DESCRIPTION OF DIFFERENCES

between CURRENT MODEL and NEW MODEL

CURRENT MODEL	NEW MODEL
Name of Appliance :	Center Module	Center Module
Model No. :	WX-CC412	WX-CC412A
FCC ID :	ACJ9TAWX-CC412	ACJ9TAWX-CC412A
IC ID :	216A-WXCC412	216A-WXCC412A

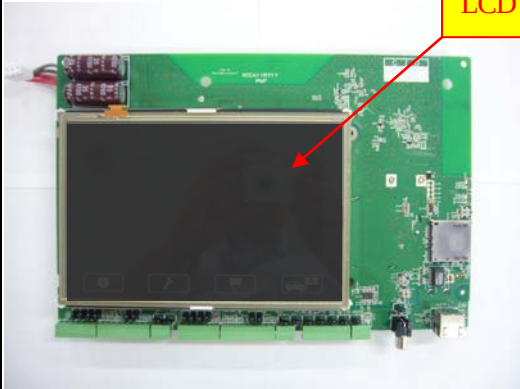
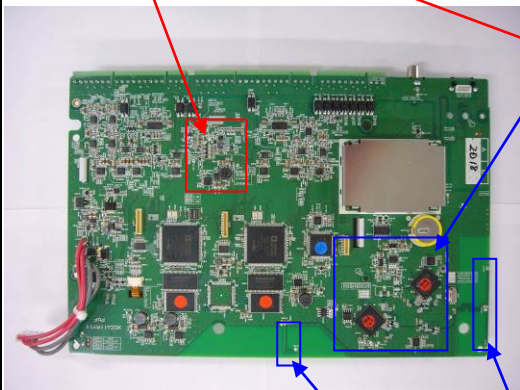
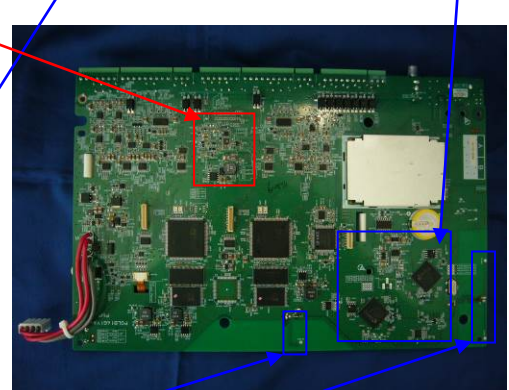
CURRENT MODEL WX-CC412	NEW MODEL WX-CC412A
LCD Display	Manufacturer: LG Display Co., Ltd. Type: LB070WV4 LCD Type: TFT 	Manufacturer: Shanghai Tianma Micro-Electronics Co. Ltd. Type: TM070RDHG20 LCD Type: TFT 
LCD Display Diver/ RF Unit/ Antenna	 LCD Display Driver 1.9GHz Antennas are same	 RF Unit (1.9GHz portion) is same 1.9GHz Antennas are same
